Lead Local Flood Authority

RE: WA/18/26/PL - Land off Arundel Road Fontwell

This is a full application for the erection of 64 residential dwellings with access off Arundel Road, together with associated parking, open space, play space, landscaping, drainage and infrastructure.

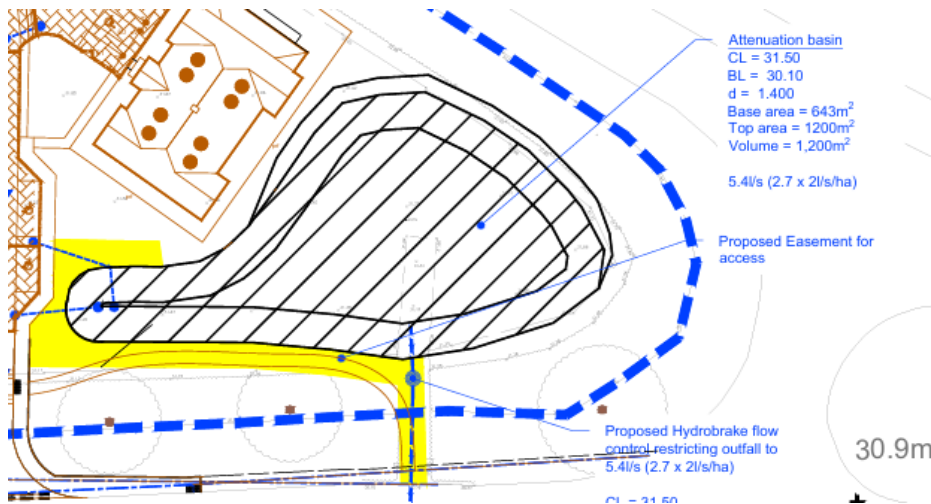
A minimum 3m easement for the attenuation basin is required, for maintenance access.

The easement shall go around the entire basin, rather than part of it. In particular for the side near the building, it is unclear whether the basin can be safely maintained.
